Building Address: 2451 MEADOWVIEW RD BLD 12 Permit No. 00-02451

MITCHELL CONCRETE

RFI # 43
2 OF 3

EXTERIOR CONDITION

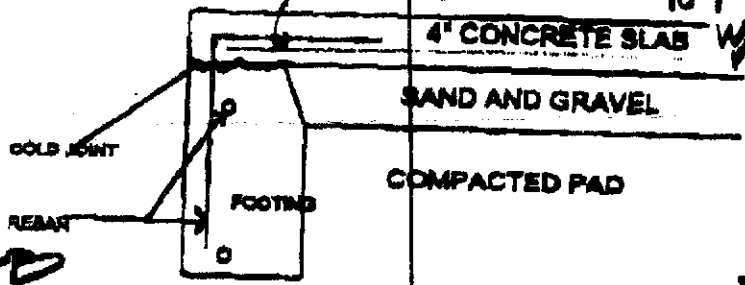
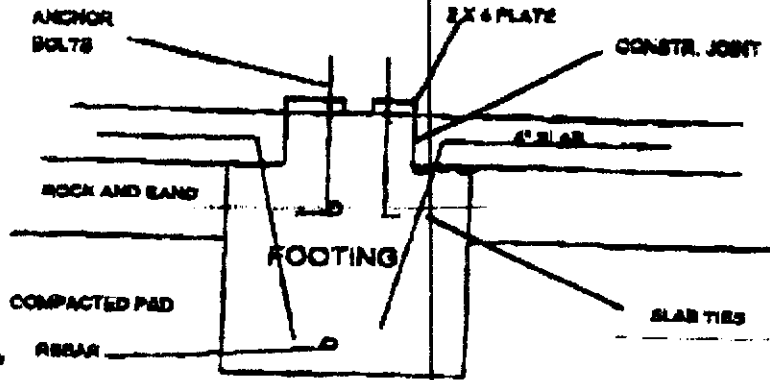
PLEASE GET APPROVAL ON THESE COLD JOINT CHANGES.

1. 2 POUR SYSTEM.

WE WOULD LIKE TO MOVE THE COLD JOINT UP TO THE BOTTOM OF THE SLAB.

18"

#4 @ 18" 2' 6" DOWN

4" CONCRETE SLAB W/ #3 @ 18" 2' 6" W.

I looked at this footing 5-15-00 RY

THE 3" OFFSET @ FTG TO F.O.S.
IS O.K. FOR TYPICAL PERMETER
CONTINUOUS FOOTING.

PARTY WALL

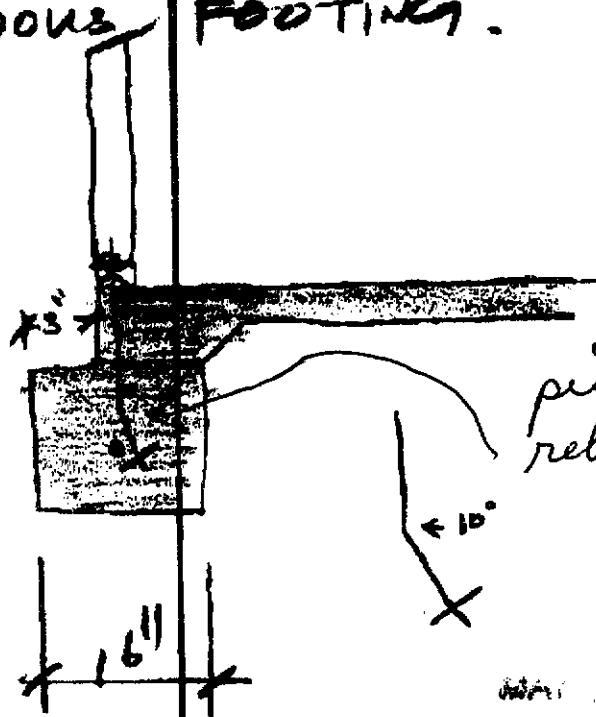
WE WOULD LIKE TO POUR A STEM WALL @ THE PARTY WALL CONDITION(S).

SLAB TIES #4 @ 18" 16" 18" DOWN
